Annex 4

4.1.1.2. Atmospheric temperature

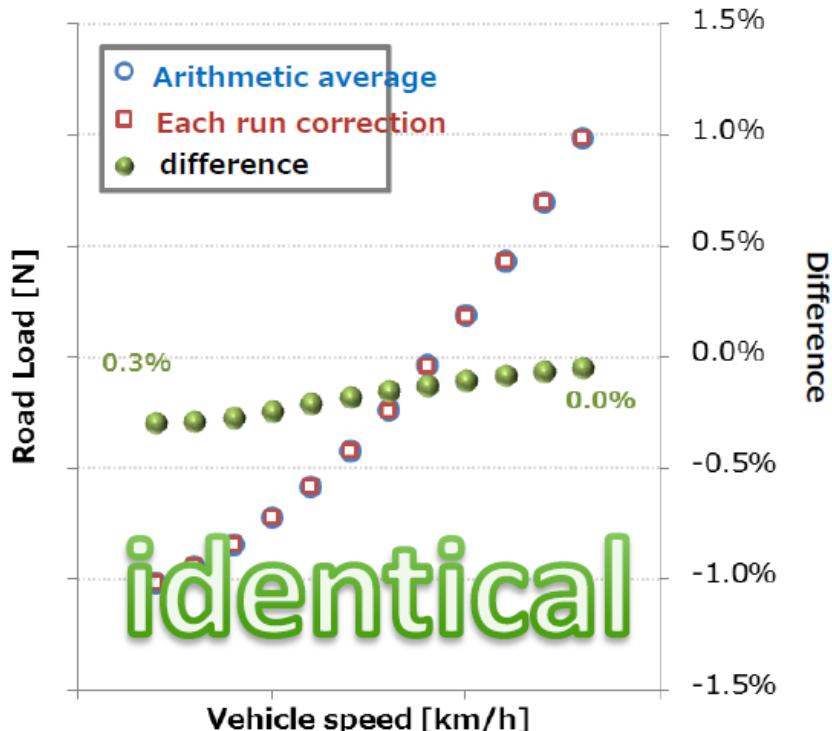
proposals	justifications
The difference between the highest and the lowest temperature : $1\sim40^{\circ}\text{C} \rightarrow 10^{\circ}\text{C}$	<ol style="list-style-type: none"> 1. Doesn't work in case of Case2b 2. Identical up to 10°C difference (refer below study) 3. No experimental study more than 10°C
Threshold of each pair run correction : $5^{\circ}\text{C} \rightarrow \text{strike out}$

The maximum difference : **13.7°C**
